# Seattle Design Commission

## **MINUTES OF THE MEETING**

**16 December 2004**

Park Site Plan

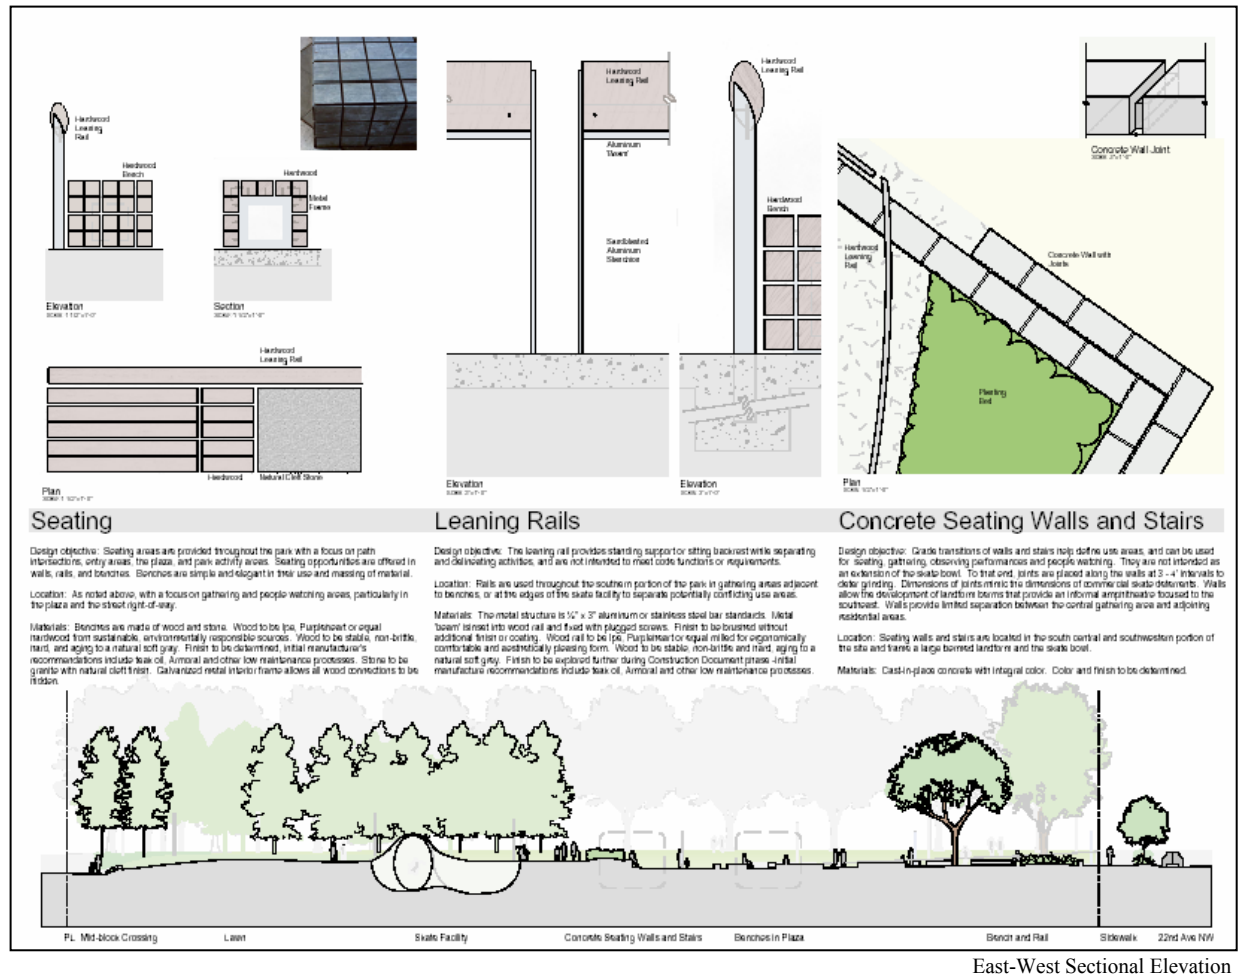
- Concerned that there seems to be a disconnect between the elegance of the plaza and water feature and the energy of the skate bowl;
- Urges proponents to continue to look at the scale of the water feature and its location within the plaza and proximity to the street;

- States that the shape of the skate bowl might integrate better with the sculptural shells that are to be used as art elements in the project, and its geography could tie in better to the sweeping curves that organize the plan;

- Encourages more opportunity to sit and watch the skating, as this will be an attraction for the area;
- States that the amount of grass used in the park design seems excessive, and suggests a focus on a more strategic use of lawn, particularly in considering whether it should be used under the birch trees;

- Urges proponents to look at more urban design opportunities of the birch grove;
- States that the design of the benches needs to be more elegant and functional;

- Urges careful consideration and selection of the big tree, its location within the space, and its proximity to the skate bowl;
- Recommends approval of design development but would like to see the project again in follow-up.

North-South Sectional Elevation

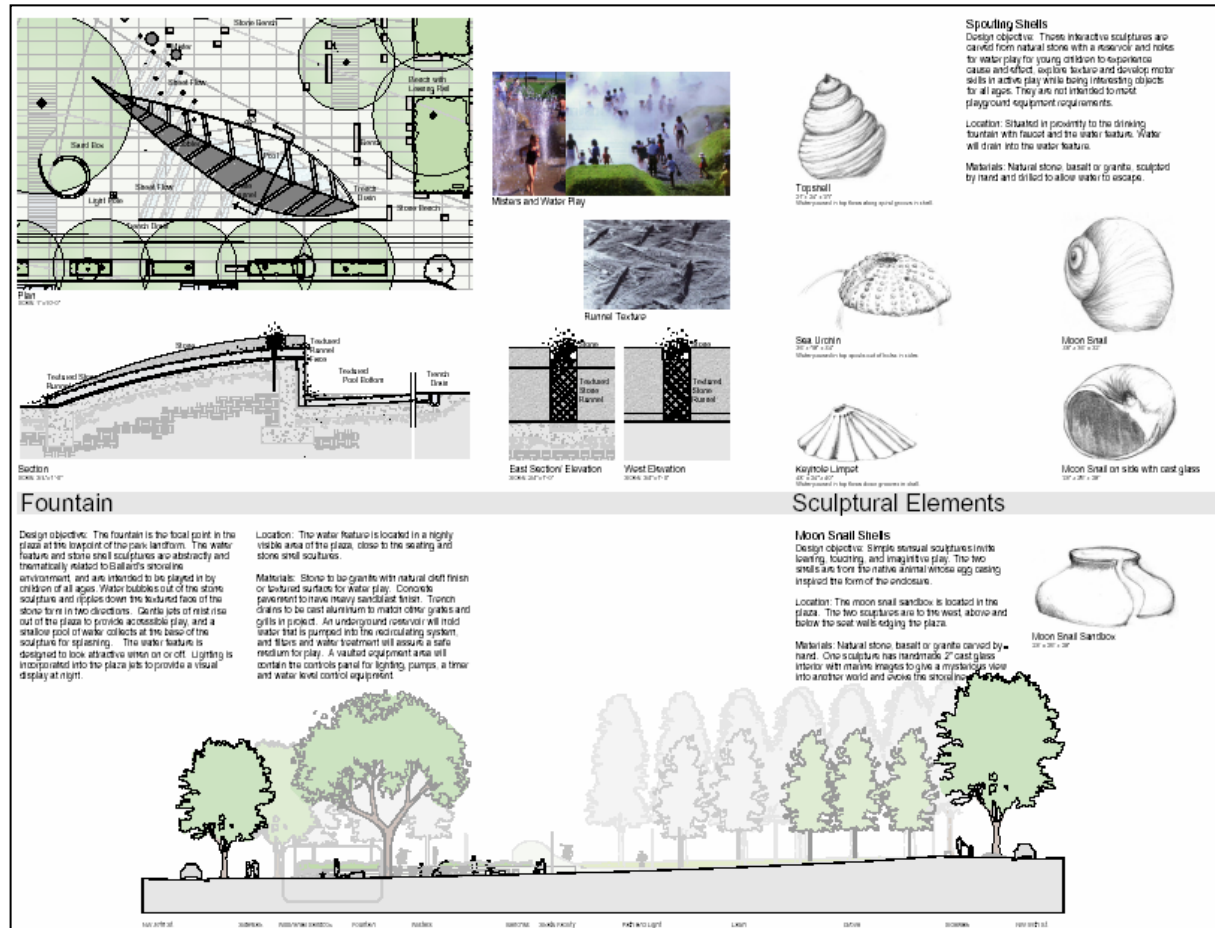
- Asks if children will play in the fountain.
  - Proponents stated that they hope many people will use the water feature.
- States that the design lacks integration of key elements. States that the challenge is in the juxtaposition of the skate bowl and the fountain.
- Asks if there is townhouse access off of the park
  - Proponents stated that the townhome contention is a code issue. Stated that the developer has chosen to build up to the property line, but could have done a setback.
- States that the community representative has some good points in terms of the benches and seating that could be addressed in the design
- States that there needs to be sun in order to appreciate a water feature. Encourages proponents to consider removing some of the surrounding trees. Further encourages a bigger bowl, but a smaller park.

- Encourages proponents to minimize the amount of grass and to include more paving.
- States that the fountain as a play area may not be appropriate. Encourages proponents to reexamine the size of the fountain and its granite blocks, and to consider reexamining its orientation to the street.

- Proponents stated that granite blocks in the fountain area are only 3 feet high. Stated that there is a need to better integrate the fountain into the site.

- States that the new design gives the feeling of two separate parks.
- States that an explanation is needed to justify the location of the big tree.
- Encourages the artist to reconsider how the edge of the skate bowl might be better integrated with the art form of the sculptural shells.

- Encourages proponents to look at an example of the tight birch grove at Tate Modern.
- States that there should be less grass and more activity areas. Questions the location of the fountain and its proximity to the street, but states that all other elements of the design seem to be in the right place. Encourages a slight tweaking of the design rather than a major shift of elements.
